IN THE UNITED STATES PATENT AND TRADEMARK OFFICE

Serial No.: 10/532,845

For: MOVING PICTURE CODING

37 CFR § 1.131 DECLARATION OF JOSEPH W. PRICE

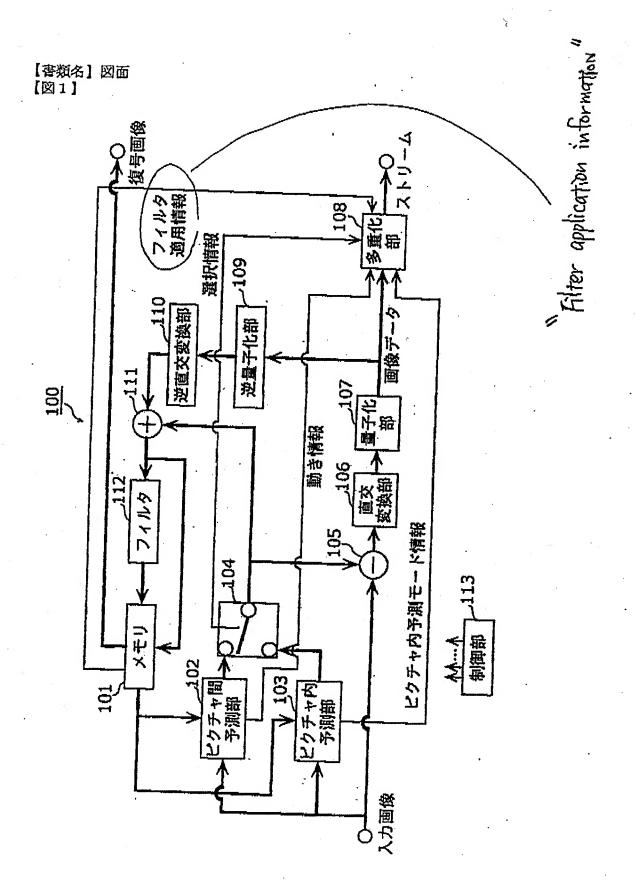
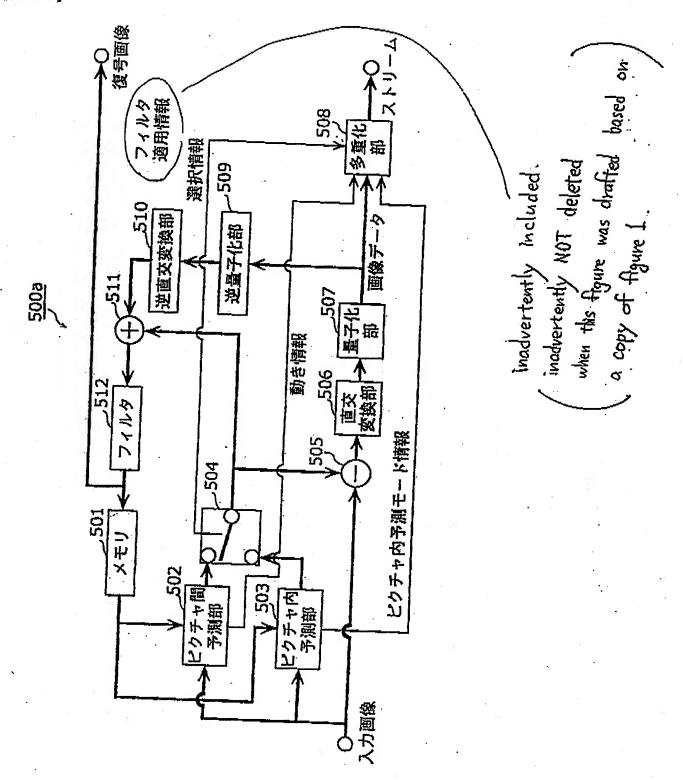
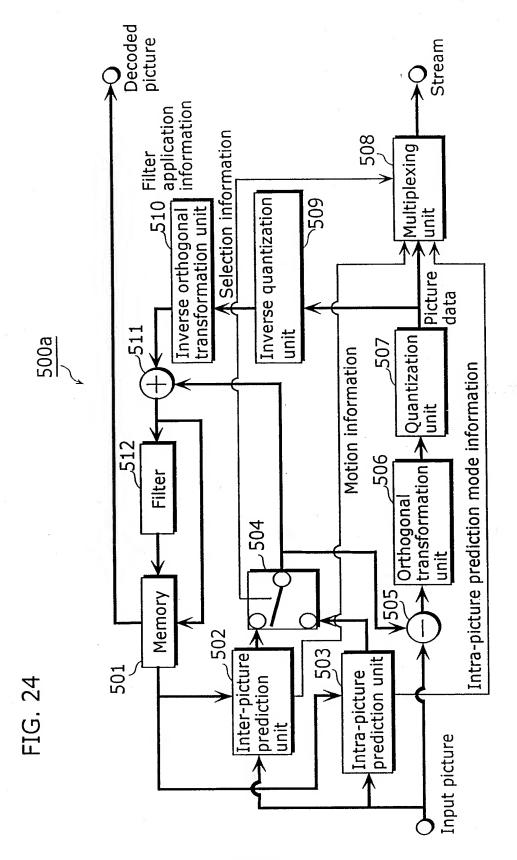
- 4. At such time I was not aware of the erroneous inclusion of a legend "Filter application information" that existed in Figure 24, nor was I aware of an inconsistency in Figure 24, of having an outputted decoded picture directly from a memory 501.

- 6. Subsequently, I was informed that the inventors had discovered errors existing in Figure 24 as to an output line for a decoded picture from memory 501 and the erroneous inclusion of a descriptive legend "Filter application information."

- 7. The error with regards to the coded picture output line from the memory 501 can be seen as inconsistent with a teaching of a comparison in our Specification on Page 8 (Exhibit D), as follows:

8. I was subsequently informed by the NII Patent Office that the error in Figure 24 had occurred when the inventors had initially prepared a description of the invention as depicted in the Japanese drawing of Figure 1 (see Exhibit A) and then used Figure 1 to provide a comparison Figure 24, as can be seen from the attached Japanese drawing, Figure 24 Exhibit B.

- 9. In view of this error, I have proposed an amendment to Figure 24 to correct an output of a decoded picture directly from the filter 512 and to remove the legend "Filter application information," as shown in Exhibit E.
 - 10. The new proposed Figure 24 is attached hereto as Exhibit F.
- 11. The erroneous presentation of Figure 24 and the subsequent marking of Figure 24 as Prior Art in an erroneous form, was unintentional and I was not aware of this error until it was recently brought to my attention from the Nii Patent Firm.
